RESPONSE TO DEADLINE 4: Cover Statement

Application by BSSL Cambsbed 1 Limited for an Order Granting Development Consent (DCO) for the East Park Energy Farm (EN010141).

BBC Reference No.: 25/01836/DCO | Examination Ref. [REDACTED]

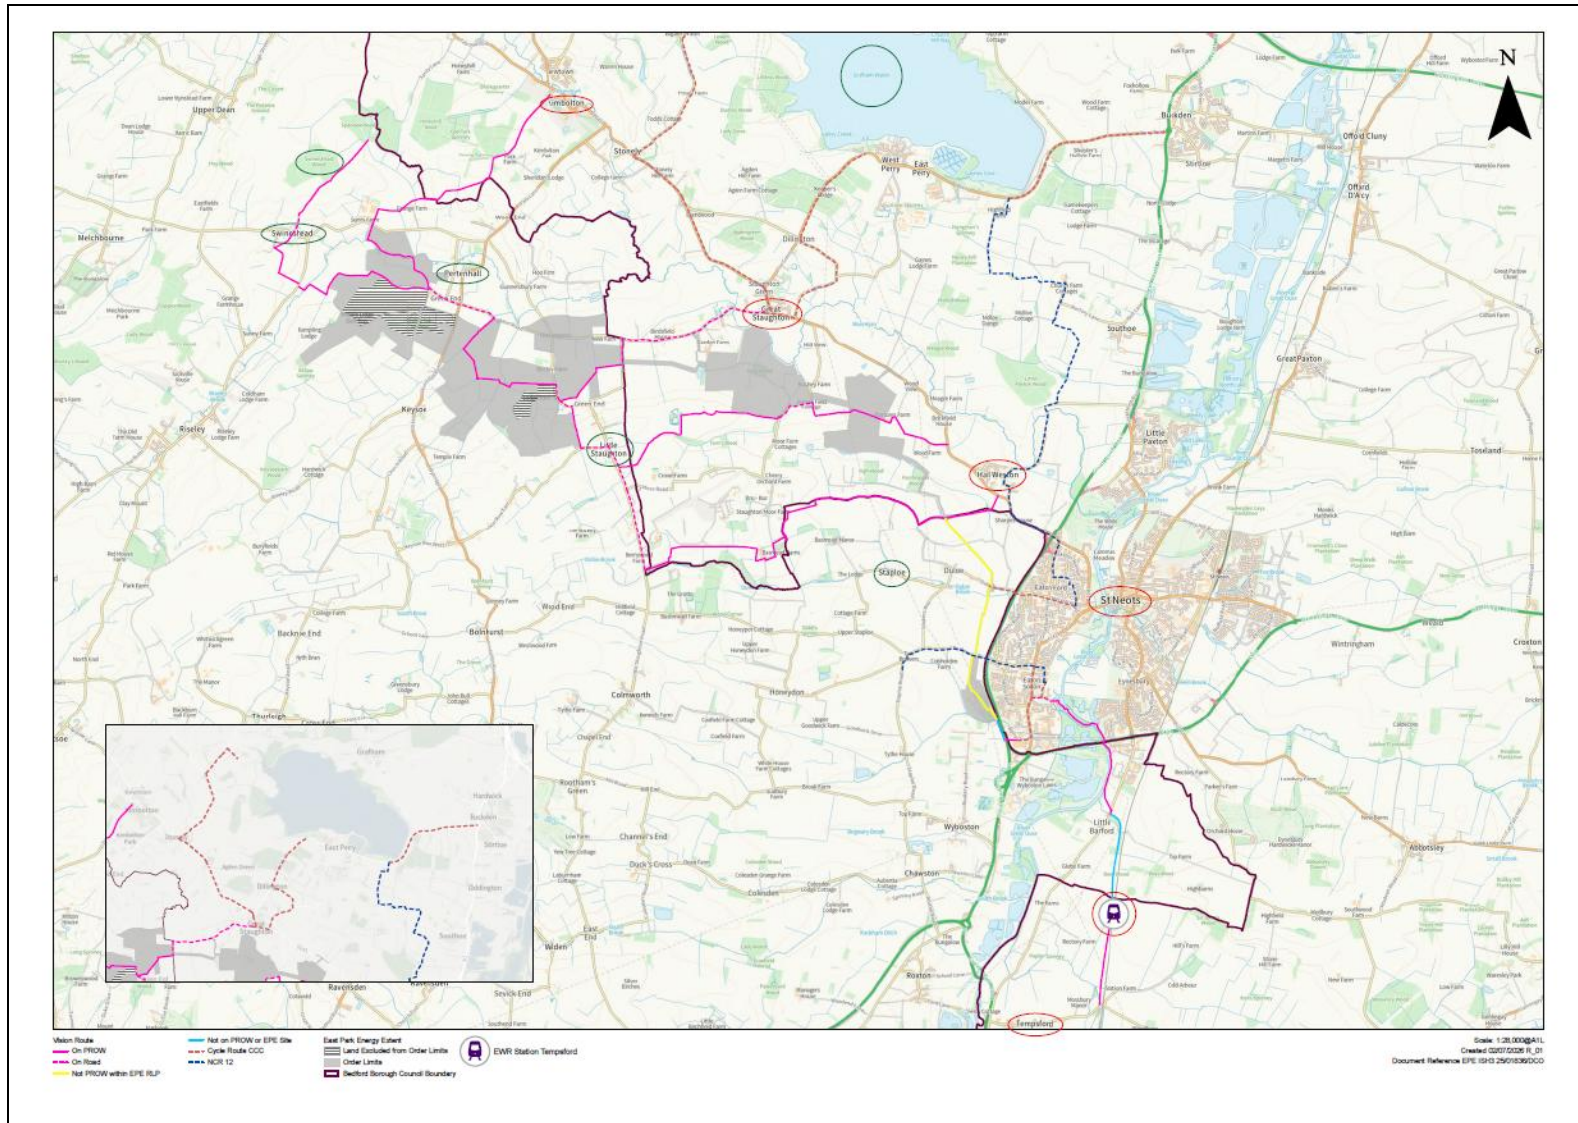
6. There are also a number of viewpoints where mitigation encloses views alongside PRow and impacts are assessed to be significant during construction, reducing to non-significant effects from Year 0. During the Issue Specific Hearing 3 on Public Rights of Way, the Applicant provided evidence in relation to Viewpoint 12 and the assessed moderate adverse (non-significant) effect, arose as a result of the retention of part of the open view from that location. This is at odds with the assessment for impacts on PRow users where assessed impacts are reduced to non-significant effects at Year 10 when there is a total enclosure of the view from solar panels and/ or mitigation planting. Examples within ES Appendix 5-4 Effects at Viewpoints P01 [APP-072] include:

- a. Receptors at viewpoint 15 (Footpath 29) as illustrated on Figure 15.19 Viewpoint 15 [APP-131] are assessed to result in a major adverse significant effect during construction, reducing to

- b. Receptors at viewpoint 77 (Bridleway 112/7) as illustrated on Figure 15.81 Viewpoint 77 [APP-142] are assessed to result in a moderate to major adverse significant effect during construction, reducing to moderate adverse non-significant during Year 0, and further reducing to minor to moderate adverse non-significant effect at Year 10. The proposed mitigation would enclose the view, although it is noted that there are gaps in the vegetation which allow for buried utilities, mitigation largely restricts views along the line of the PRoW.

- c. Receptors at viewpoint 78 (Footpath 112/5) as illustrated on Figure 15.82 [APP-142] are assessed to result in a moderate to major adverse significant effect during construction, reducing to moderate adverse non-significant during Year 0, and further reducing to minor to moderate adverse not significant effect at Year 10. There would be views of solar PV panels along the majority of the route, although it is noted that there is an existing solar farm located to the south that may be visible at points along the PRoW.
